ELECTRONIC 2025 INTEGRATED RESOURCE)	
PLAN OF EAST KENTUCKY POWER)	CASE NO.
COOPERATIVE, INC.)	2025-00087
)

RESPONSES TO STAFF’S SECOND INFORMATION REQUEST
TO EAST KENTUCKY POWER COOPERATIVE, INC.

DATED MAY 15, 2025

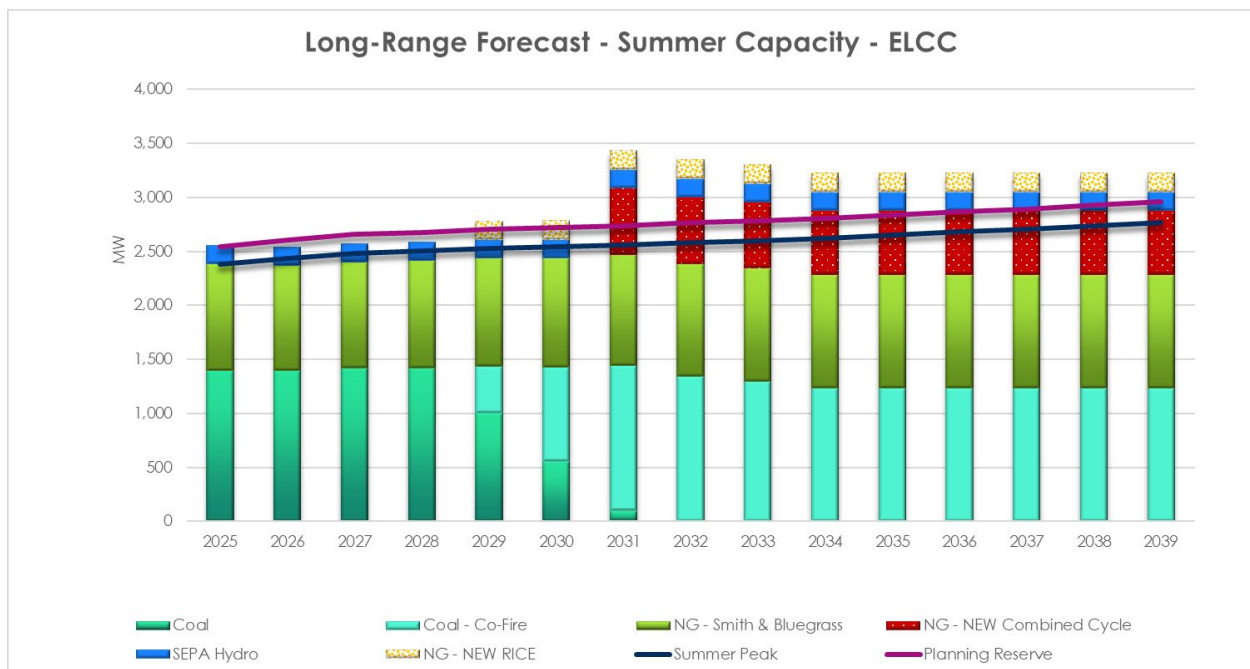
b. Refer to Case No. 2024-00370, EKPC's Response to Commission Staff's Fourth Request for Information, Attachment JJT-4 Revised. In that attachment, EKPC adjusted its summer capacity and reserve margin requirements to account for PJM summer obligations. Explain why a similar adjustment was not made in the IRP. Include in the response an explanation of whether Table 8-3 and 8-6 would match the data presented in Attachment JJT-4 Revised.

a. The "Energy Additions" column represents seasonal Winter PPAs.

b. EKPC chose to be consistent with past IRPs regarding the Summer capacity values as shown in Table 8-3. The data presented in Attachment JJT-4 Revised is close, but not exactly the same as an ELCC-adjusted summer capacity value from Table 8-3 as the PJM-published ELCC class-average data has been updated since Attachment JJT-4 Revised was produced. An updated version of Attachment JJT-4 Revised is attached to this response, see *Staff 2-28b - EKPC IRP 2025 Resource Expansion Plan.pdf*. The RICE and Cooper CCGT resources are already accounted for in the base plan in the years 2029 and 2031, respectively, and therefore are not labeled as additions within the plan. See updated chart below showing ELCC-adjusted generation and summer PJM load obligation.
